SERVICE BULLETIN NO. RSB 817-77

ATA-Code: 79-20 Oil Cooler and Oil Thermostat
Modified oil-cooler bracket

Figure 1 Overview Engine

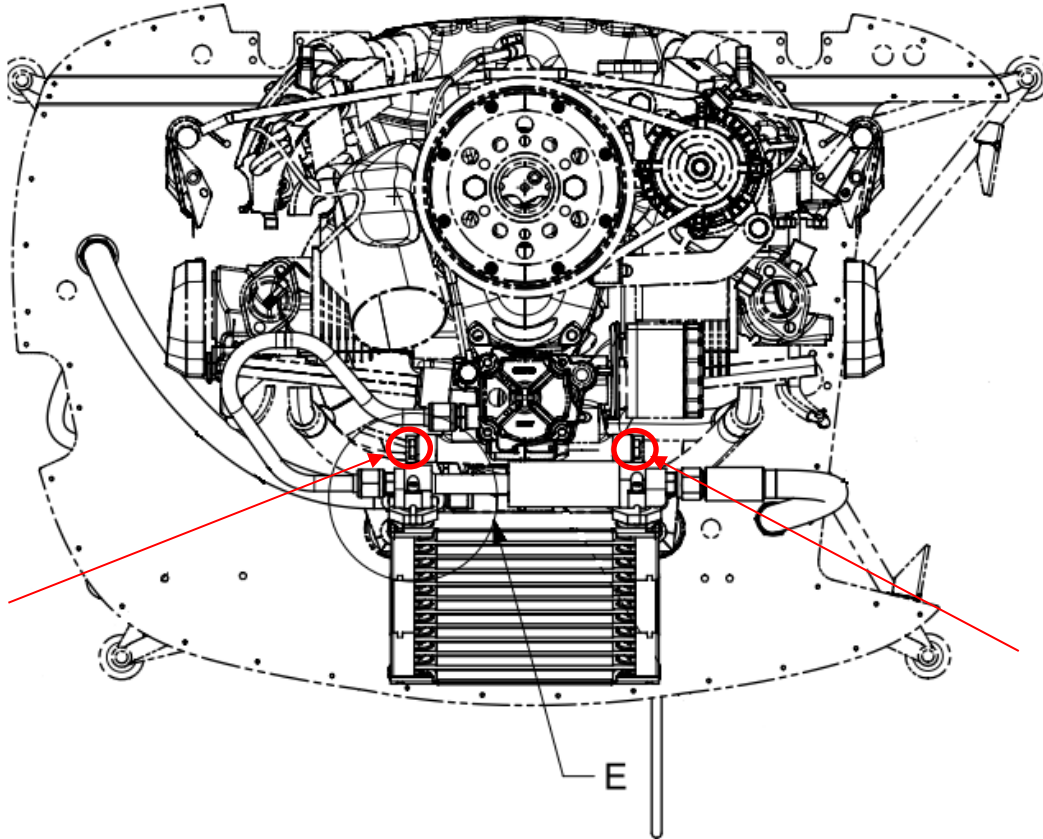
The weld on the oil cooler adapter that holds the oil cooler can be modified to improve durability. This Service Bulletin is intended to improve the reliability and service life of the oil cooler adapter. The configuration of the aircraft is affected by this Service Bulletin.

- 1.8.1 Make the aircraft safe for parking, refer to AMM Chapter 10-10.
- 1.8.2 Remove the L/H and R/H cowlings, refer to AMM Chapter 71-10.
- 1.8.3 Remove the old adapter weld assy, refer to Figure 1 and keep the bolts and washers.

- 1.8.4 Install the new adapter weld assy R/H, item 1 of list 2.2.
- 1.8.5 Secure the highlighted R/H bolt, refer to Figure 1, with screw locking adhesive LOCTITE 243 (GS513007).
- 1.8.6 Install the new adapter weld assy L/H, item 2 of list 2.2.
- 1.8.7 Secure the highlighted L/H bolt, refer to Figure 1, with screw locking adhesive LOCTITE 243 (GS513007).
- 1.8.8 Install the L/H and R/H cowlings, refer to AMM Chapter 71-10.
- 1.8.9 Release the aircraft back into service according to national requirements.
